Title: Advisory Committee on Reactor Safeguards
Thermal-Hydraulic Phenomena Subcommittee
OPEN SESSION

Date: Thursday, March 20, 2003

<u>AGENDA ITEM</u>	<u>PAGE</u>
Open Session	179
Presentation by Mr. Andre Gagnon	179
Presentation by John Segala	227
Presentation by Dr. Steve Bajorek	232

AP1000 DVI Line Break

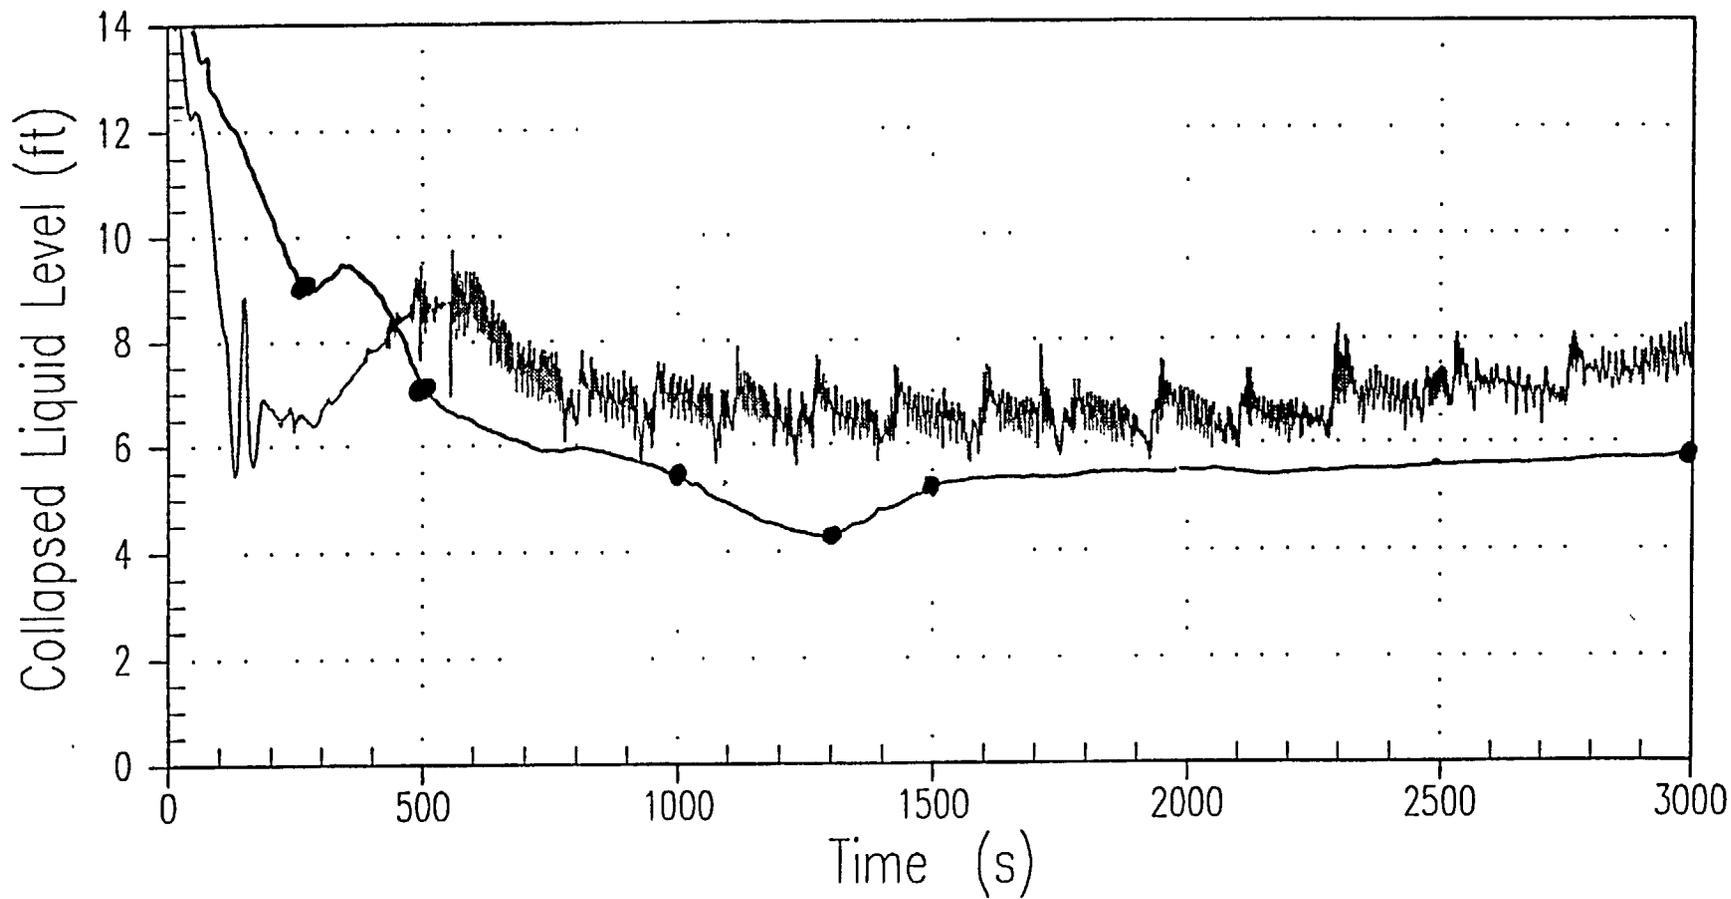
20 MR. GAGNON: Okay. One of the requests
21 that we had yesterday was to provide a comparison plot
22 of the core collapsed level and some void fractions.
23 We have a comparison of the core collapsed level for
24 the DVI line break.

25 As you can see the RELAP is about a foot

1 lower than the NOTRUMP at its minimum, and trending in
2 the same direction. NOTRUMPS and IRWST injection time
3 for this simulation is approximately 2,076 seconds,
4 and so we are not starting to really start injecting
5 IRWST here.

16 CHAIRMAN WALLIS: Well, the liquid level
17 is going up after 2000. I was looking at the
18 collapsed liquid level.

AP1000 DVI 14.7 (Half PRHR), ADS-4 K Increase by 70%.

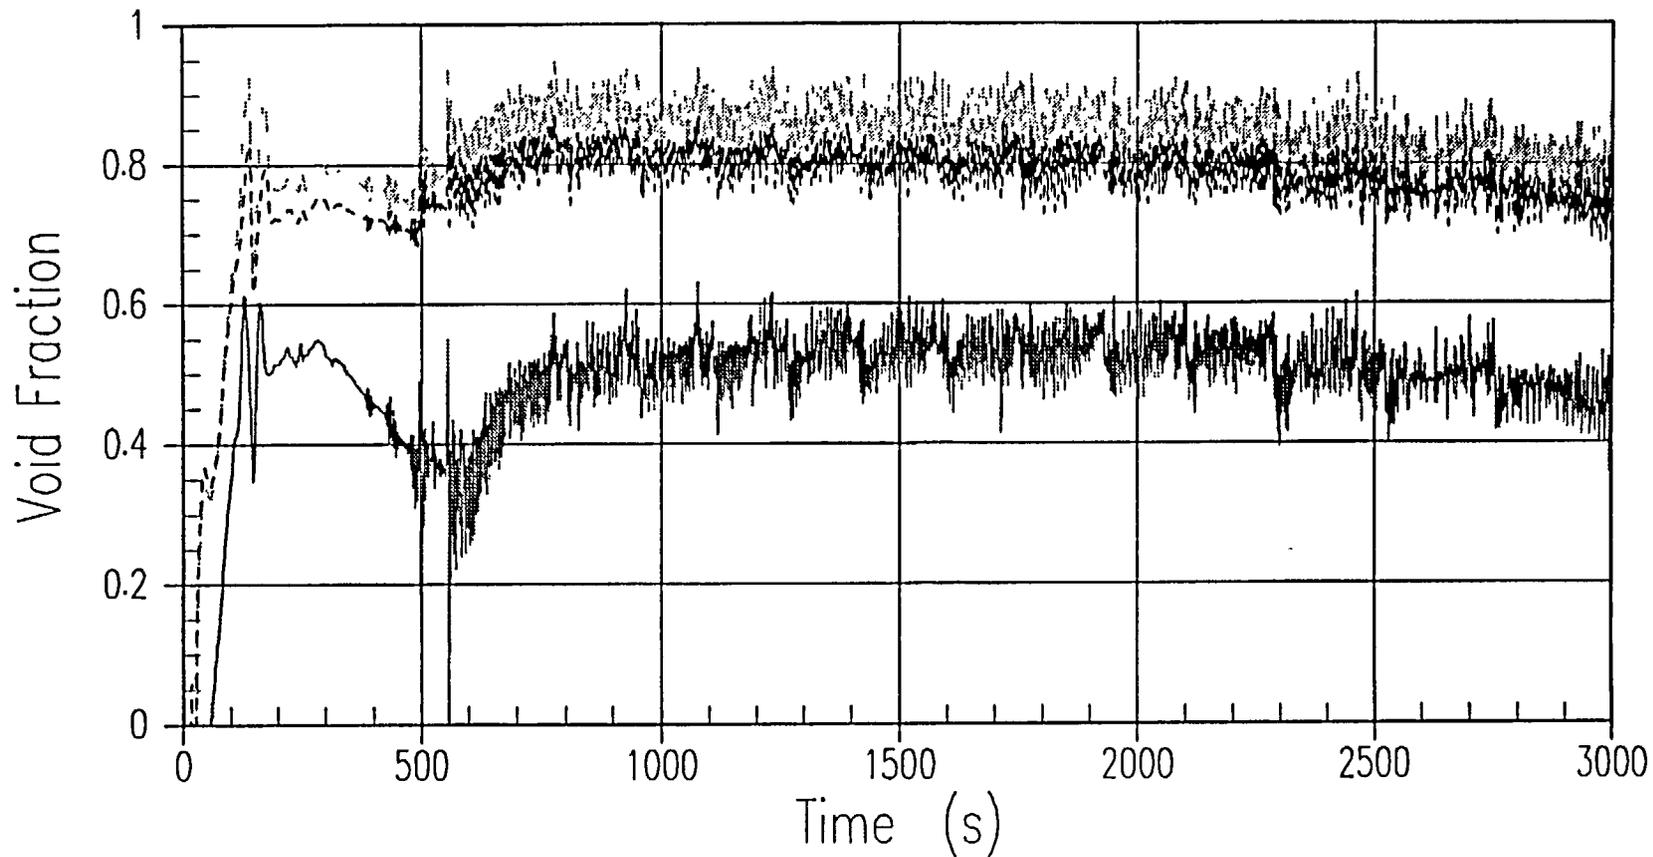
6 One of the other plots presented yesterday
7 was the core void fraction. One of the things to note
8 is that the NOTRUMP core contains 14 axial segments,
9 and NOTRUMP was also validated against the G2 14 foot
10 course facility, as well as Achilles.

11 G2 was run in a pressure range from 700
12 down to near atmospheric conditions. One of the
13 things that you will note here is that I think that we
14 are lower than the predicted value at mid-plane for
15 RELAP-5 for Walt's presentation yesterday, and we are
16 at near the similar values for near the top of the
17 core.

18 One of the things to note is that we have
19 a 14 foot axial core power shape that we are utilizing
20 in this simulation, which the top core nod is at
21 substantially lower power than the previous core nods.
22 So the peak power NOTRUMP is core node 13.

23 DR. BANERJEE: Core node 13 is the
24 highest?

2 DR. BANERJEE: Is it also the highest core
3 average void fraction?

25 MR. GAGNON: Yes. It is also the peak

4 MR. GAGNON: Yes. This is the core
5 average void fraction for this case. You can see
6 where the core average is roughly between 50 and 60
7 percent.

AP1000 DVI Line Break

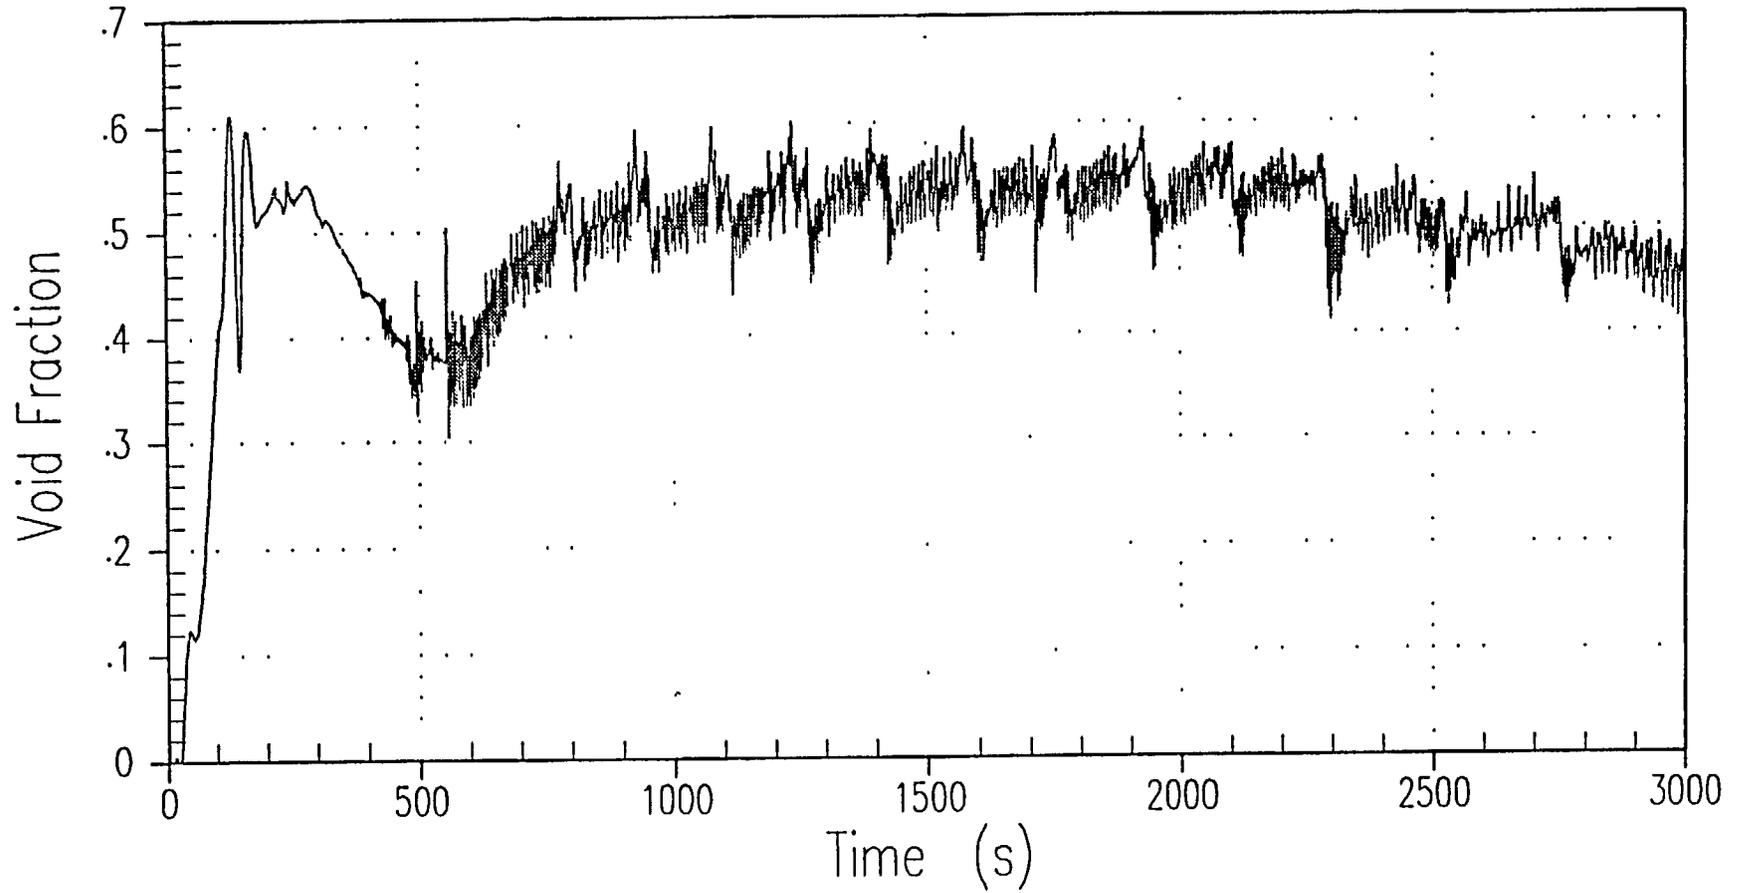
8 MEMBER KRESS: What causes the
9 periodicity? It looks like it is fixed --

17 DR. BANERJEE: This is increased
18 resistance in the ASD-4 line?

20 CHAIRMAN WALLIS: This is the build up of
21 liquid in the riser part of the line; is that what it
22 is?

3 CHAIRMAN WALLIS: And when it gets to the
4 valve, it increases the pressure and drops the flow a
5 bit?

10 MR. WRIGHT: We are getting pressure
11 oscillations as to when we start slugging flow out of
12 ADS-4. We have periodic discharges out of four, and
13 at that point --

19 MR. GAGNON: Yes.

23 MR. GAGNON: Yes, we get liquid into
24 contact and we suck it out, and we pressurize.

6 MR. GAGNON: Yes.

AP1000 DVI 14.7 (Half PRHR), ADS-4 K Increase by 70%.

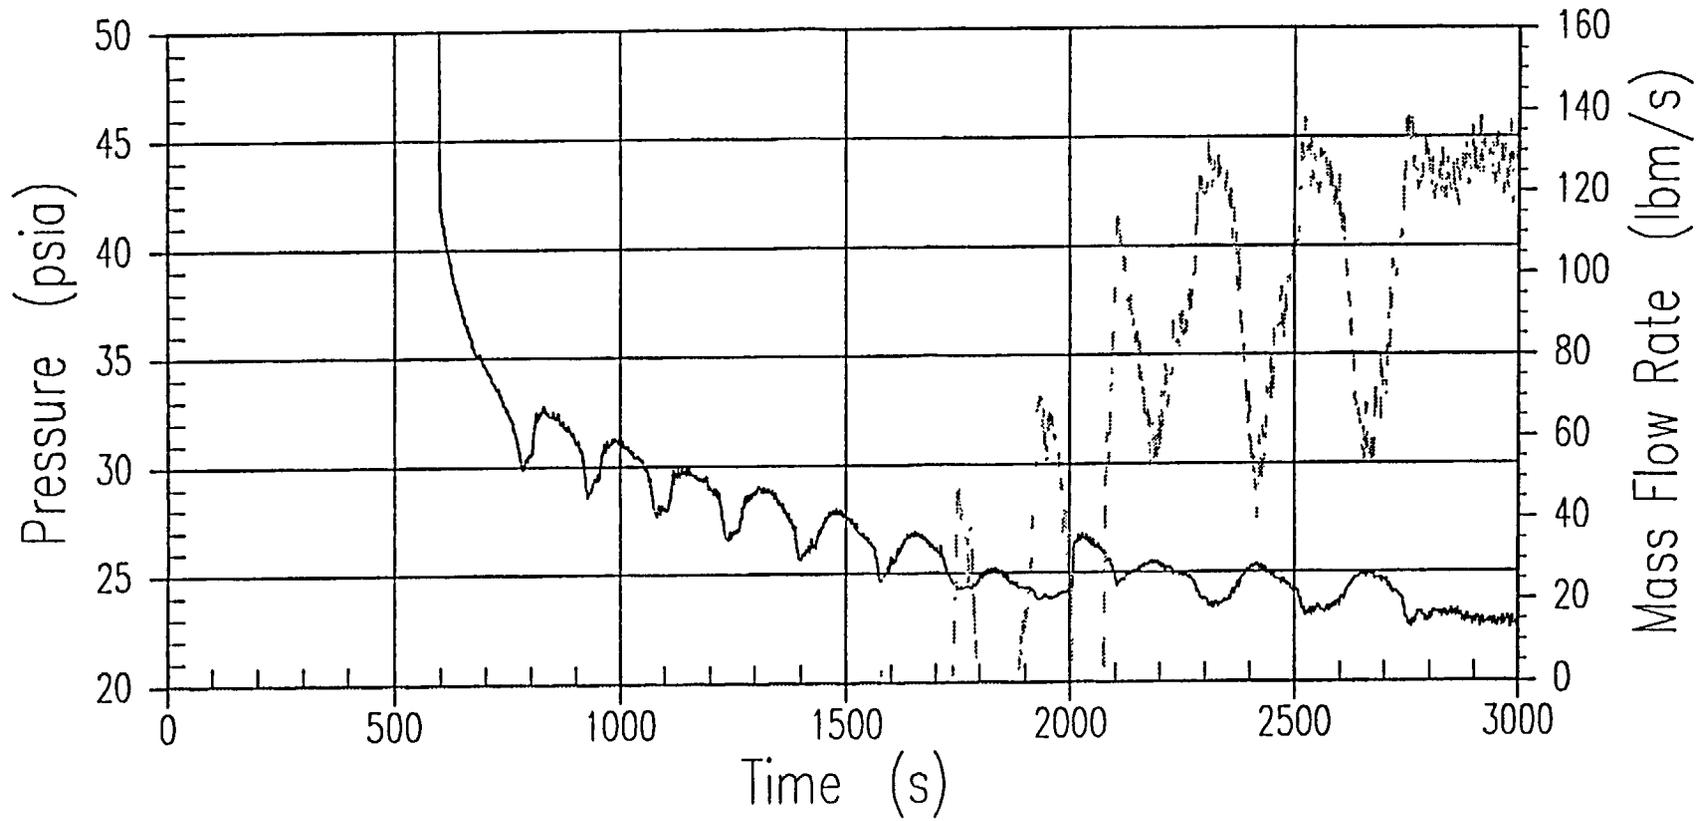
13 MR. GAGNON: This is the DVI line
14 pressure, compared to our IRWST injection flow, and as
15 you can see when we slip down to about 25, I believe,
16 psi in order to get our IRWST injection flow. You can
17 see the kind of behavior that we are getting as we
18 plug the ADS-4, and vent it, and with the
19 pressurization we get a blip, and it comes in and
20 plugs it again.

21 And once we can get it clear sufficiently,
22 we start getting more stable IRWST flow. This is the
23 10 inch break, and we don't have the RELAP curve on
24 here, but --

AP1000 10 Inch Break in Fluid Node 49 (Cold Leg)

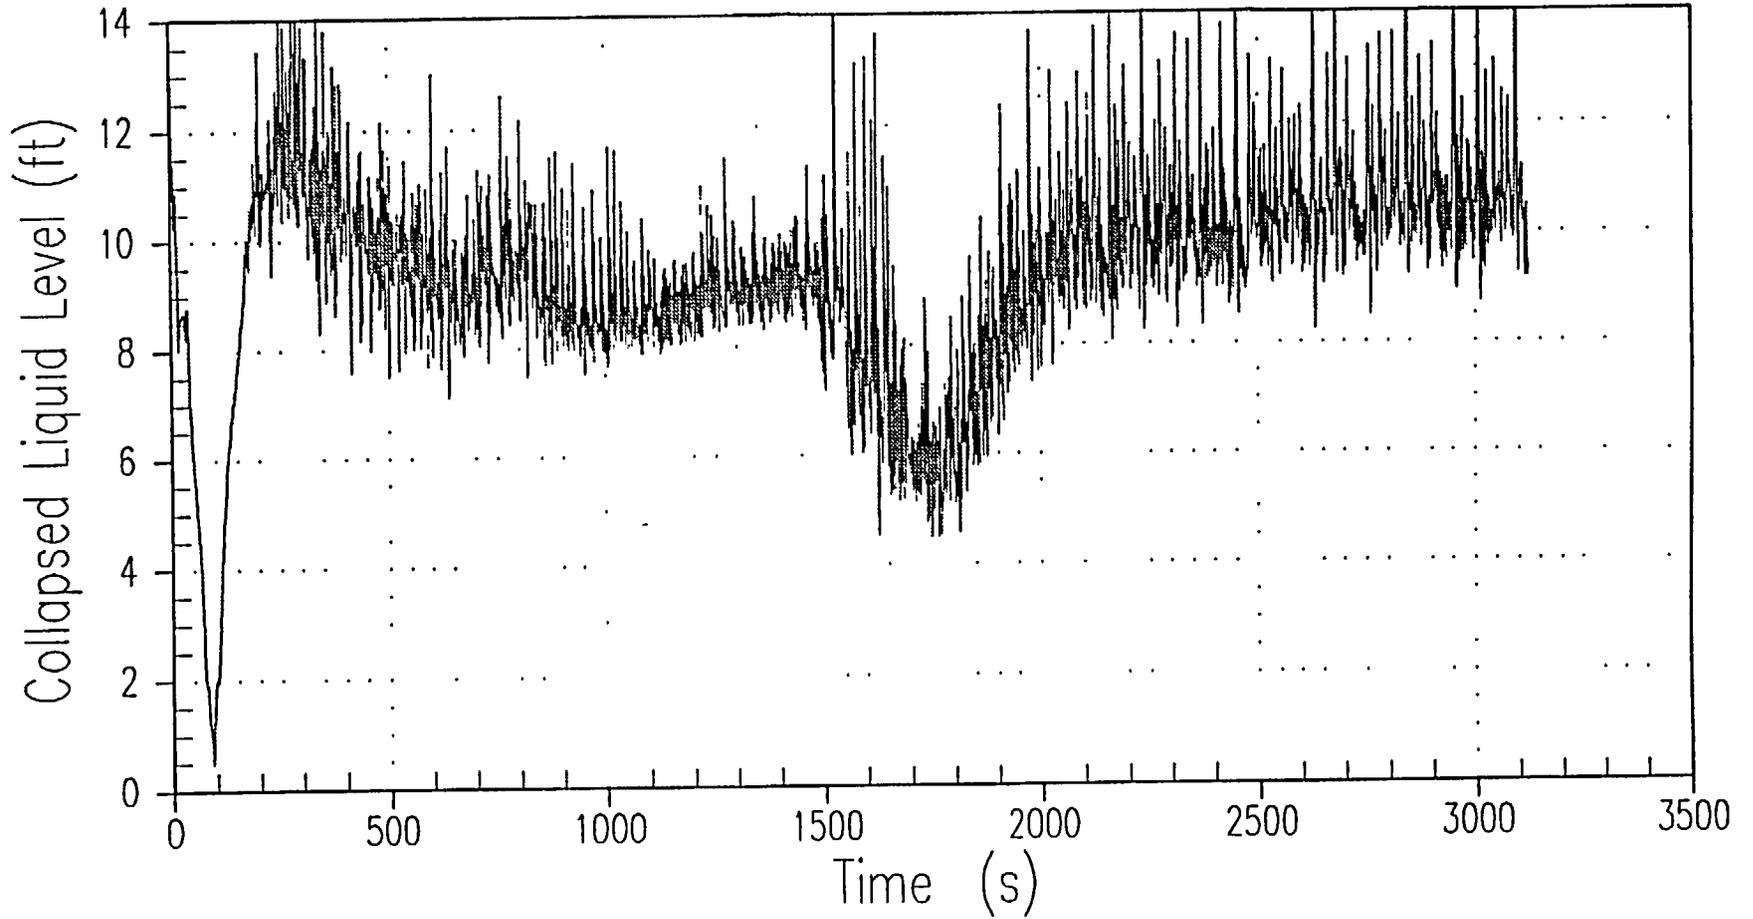
2 MR. GAGNON: That was the purple curve
3 from yesterday, and they were predicting approximately
4 a 30 percent core level as their minimum. And you can
5 see with NOTRUMP that the collapse level is down
6 around -- oh, half a foot. This is in the active
7 shield area, and so it is very highly voided, and that
8 is why we did the adiabatic to heat up the
9 calculation.

10 And while it didn't predict the
11 traditional mixture level uncover, we said these void
12 fractions are just too high to say that it is not going
13 to be a brief blowdown. I mean, this is a high
14 pressure type uncover.

15 DR. BANERJEE: And five foot is the
16 minimum roughly?

18 CHAIRMAN WALLIS: And so 30 percent is
19 something like 4 foot? It is about the same when you
20 get out further. The RELAP calculation would be about
21 the same or the minimum.

17 MR. CORLETTI: In the long term, yes.
